# Traffic Impact Assessment Addendum Report

02-Mar-2026  
West Mokoan Solar Farm

It provides an overview of the proposed access changes to the West Mokoan Solar Farm and inform a Section 57A Amendment to the existing planning permit application. These changes are documented in the current plans, titled '*West Mokoan Solar Farm\_LP3-BDL\_21 (KC\_BDL\_05) Planning*'.

Figure 1 Summary of proposed access changes

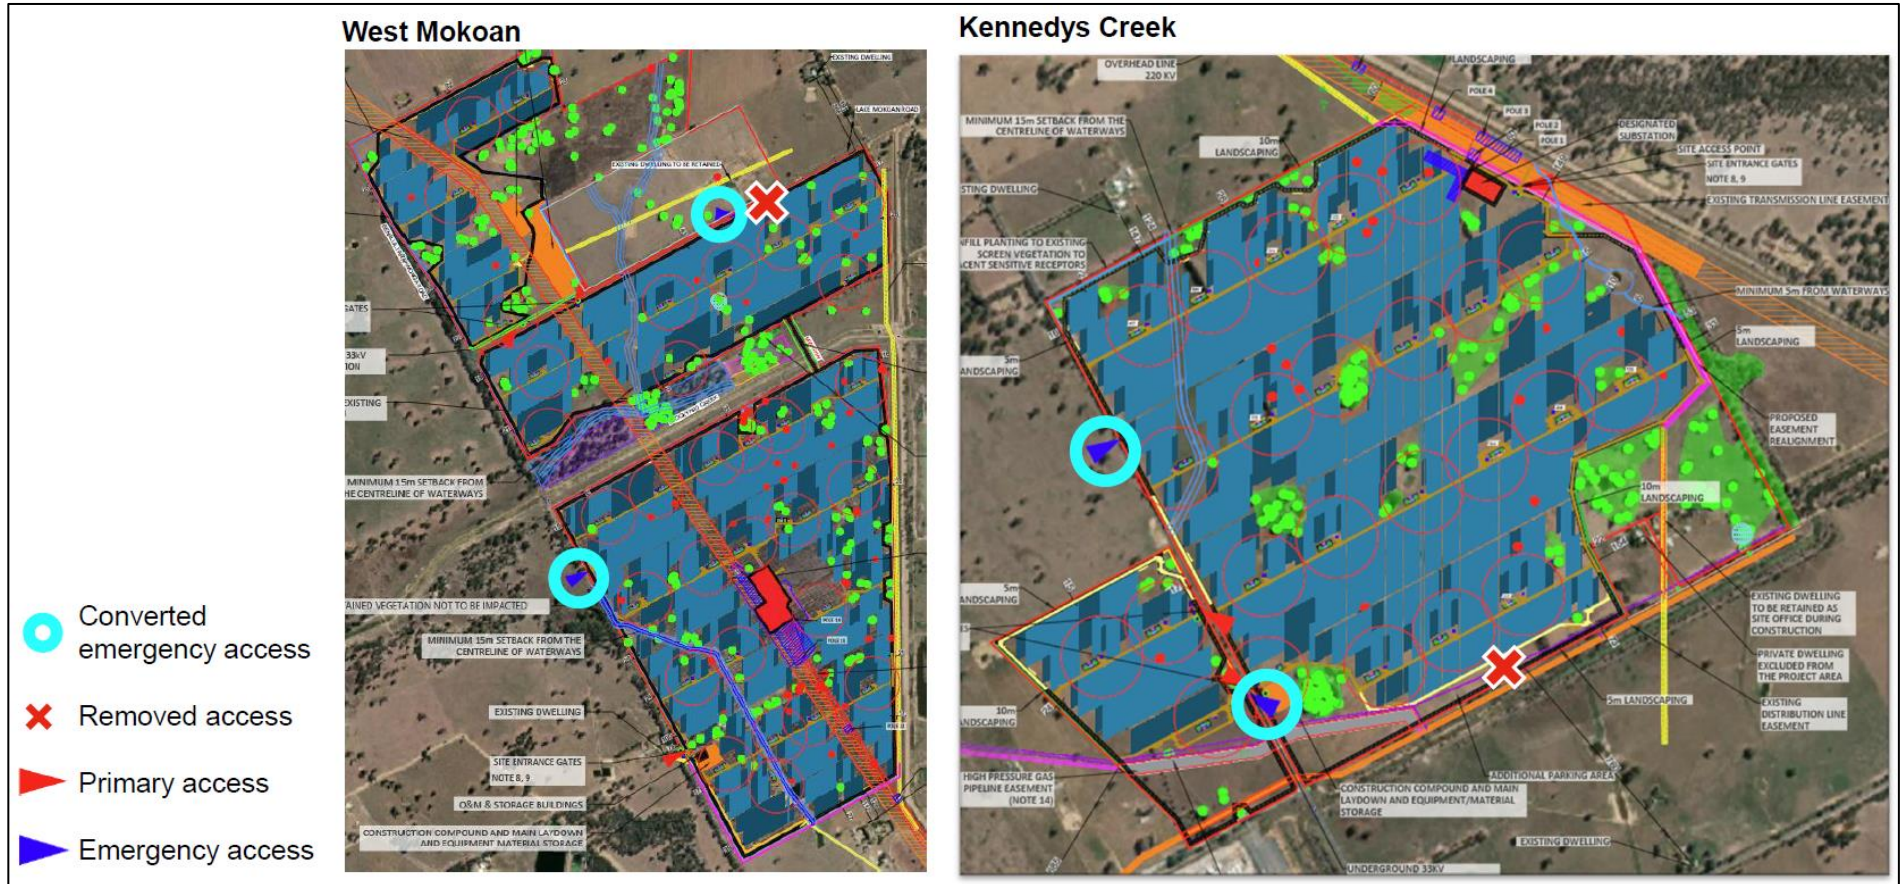
This memorandum considers the following proposed changes to access, identified in Figure 1:

- Removal of the Nelsons Road access (Kennedys Creek site)
- Removal of 81 Lake Mokoan Road access (West Mokoan site)
- Four access points to become 'emergency access' only, comprising:
  - Eastern-most access off Lake Mokoan Road (West Mokoan site)
  - Northern-most access off Benalla Yarrowonga Road (West Mokoan site)
  - Northern-most access off Benalla Yarrowonga Road (Kennedys Creek site)
  - Southern-most access off Benalla Yarrowonga Road (Kennedys Creek site).
